**Hastings District Council**

**Commissioner Hearing Meeting**

**LIMITED NOTIED RESOURCE CONSENT APPLICATION FROM No.  
8 STUDIOS LIMITED TO ESTABLISH A SCREEN PRODUCTION  
SUTDIO IN THE RURAL ZONE AT GORDON ROAD AND 376  
PARKHILL ROAD, TE AWANGA (RMA20210474)**

**RE: RESPONSE TO S92 REQUEST – RMA20210474, NO8 STUDIOS LTD, TE AWANGA**

Figure 3: Typical Cross Section

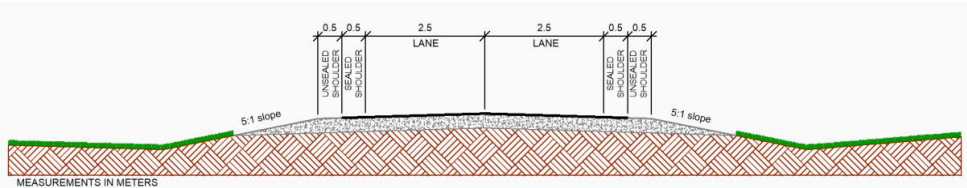
- We acknowledge receipt of the narrative and 'Typical Cross Section' diagram provided in response to this item in Section 4 of the Urban Connection letter (dated 17 November 2021) provided with the s92 RMA response. However, no feedback (e.g. a letter or email) has been provided from FENZ confirming that they are satisfied that the proposed access road is consistent with the FENZ emergency vehicle access guidelines. Please provide this confirmation.

At 6m wide the sealed cross section for the access road is wider than many public roads, including existing sections of Parkhill Road which is 3.6 – 5m wide for the last 1km to the site. With unsealed shoulders and 5:1 batters (refer Figure 3) vehicle’s will be able to pull over to provide safe access for emergency vehicles. Final details and checks of ensuring emergency access are available to and around the site will be dealt with in the detail design and building consent stage. Given the greenfield nature of the development there are no barriers to meeting these requirements at the time of detailed design. The access road will have a 50km/h speed limit.

**1. Item 5 – Provision of On-Site Parking:**

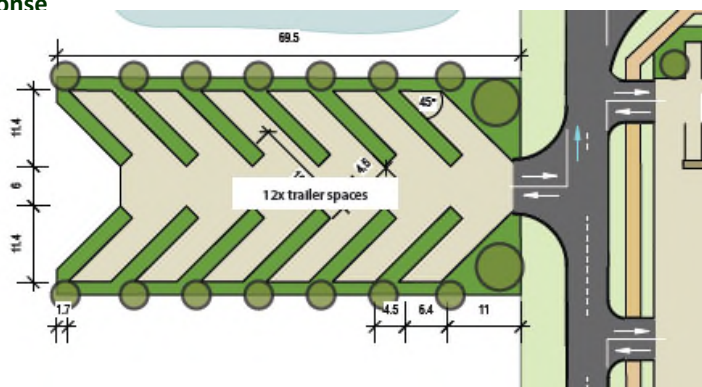
- While the additional drawings from Wayfinder (provided with the s92 response) show the on-site parking area dimensions, the layout (see below) does not demonstrate how trucks will manoeuvre safely to drop/pick up trailers within the 12x trailer spaces parking area. Please provide details of tracking for vehicles within the trailer spaces carpark area.

**Figure 5: Existing access route from Clifton Road to Parkhill Road through the Te Awanga Estate property.**

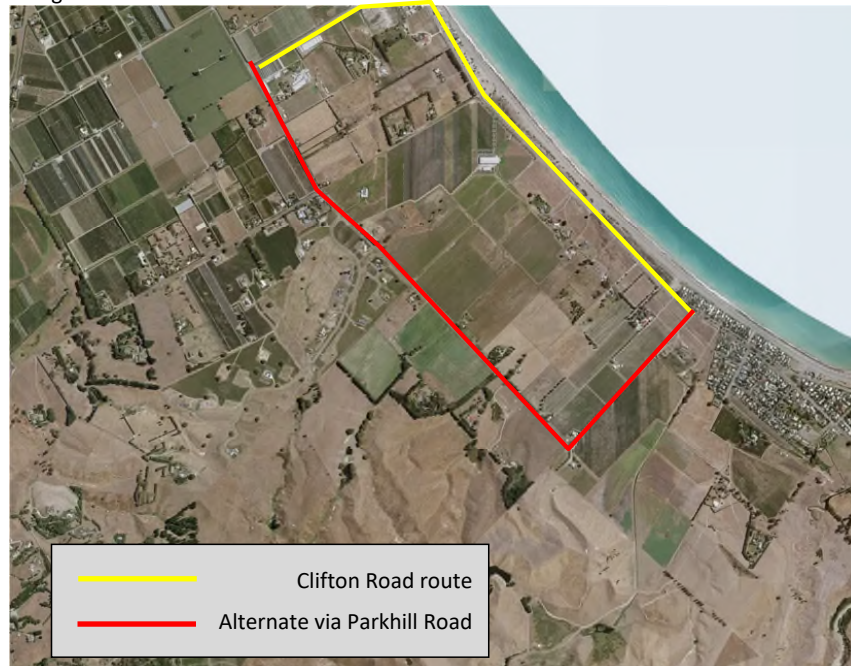
- 4.9 A matter of concern raised by submitters is the potential for traffic from Clifton Road using the existing shingle driveway through the Te Awanga Estate Winery to access Parkhill Road, being the more direct traffic route.

- 4.10 The current Te Awanga Estate vineyard access enables direct public movement over private land to Parkhill Road, to gain access to the Te Awanga Estate Winery, and onward to Parkhill Road. Use of the access is at the discretion of the landowner.
- 4.11 In considering the current use, and traffic movements, I am of the opinion that the existing traffic movements would be accounted for in the current Parkhill Road traffic volumes and have therefore already been taken into consideration in my assessment of traffic effects relating to the proposed film studio.

Figure 6: New road / Outfoxed proposed intersection scheme layout

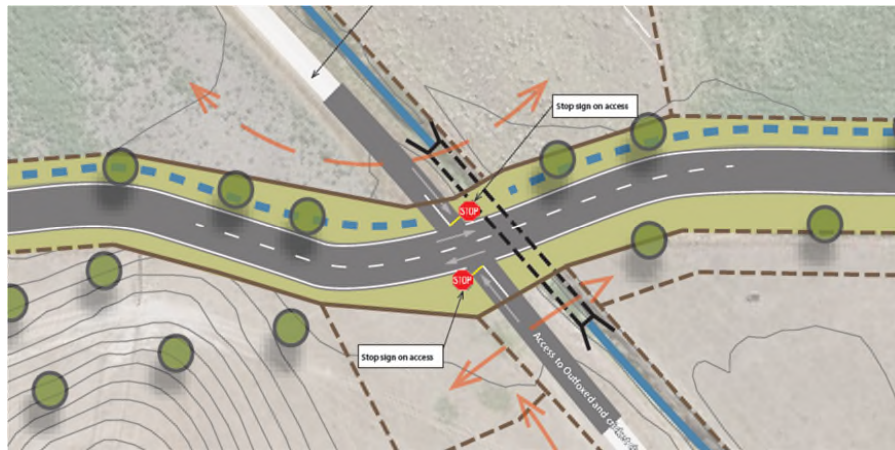
- 4.22 I believe the proposed access road to the studio requires site specific topographical survey and geometric design to ensure that approach road angles and the maximum intervisibility sight lines are achieved

- 4.23 The final design resulting from the topographical survey and utilising best practice design should be subject to a formal RSA, undertaken by an independent and appropriately trained Road Safety Team.

Figure 8: New road security gate scheme layout

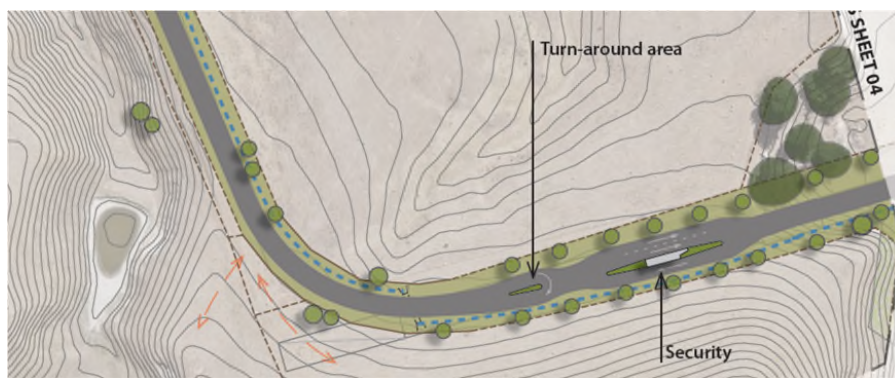
- 4.31 The latest iteration of the design proposed for the film studio access road includes two specific security check points / barrier arms, as indicated in Figure 7 and Figure 8 below.

- 4.32 Each of the security points / barrier arms details facilities for a turnaround should a vehicle not be permitted to travel any further into the complex. The details supplied are diagrammatic only and will require confirmation during the design phase to ensure that all reasonably expected vehicle types can undertake a U-Turn movement if required.

Figure 9: Proposed Intersection Scheme Layout

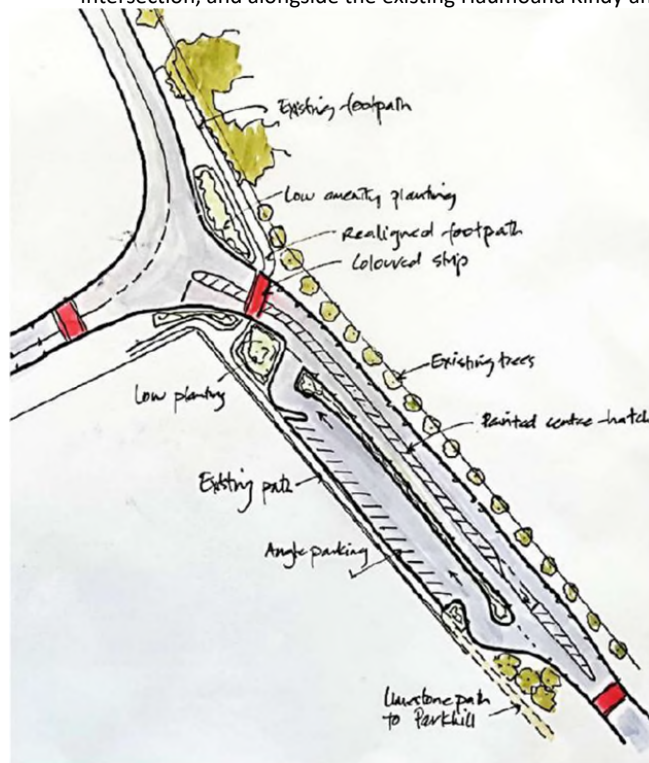
- 4.36 In reviewing the proposed remedial treatment, I generally concur with the schematic road layout. I recommend that sufficient investigation and design be undertaken as part of this application to provide Council with surety that there are no unresolvable clashes with overhead, at grade or underground services, or elements that would restrict the intersection being built to the intent of the scheme design.
- 4.37 The provision of raised tables (Figure 9: indicated in red), includes best practice under the safe system treatment – Primary treatment approach, where vertical deflection is installed to slow vehicle speeds. Critical to this philosophy is the provision of treatments that reduce

4.38 As part of the Engineering Approvals, it is my opinion that all Parkhill Road/Raymond Road intersection and road improvement works should be subject to a formal Road Safety Audit (RSA) by an independent and appropriately trained practitioner for Road Safety Audits. For clarity, the following response path should be stipulated for the RSA:
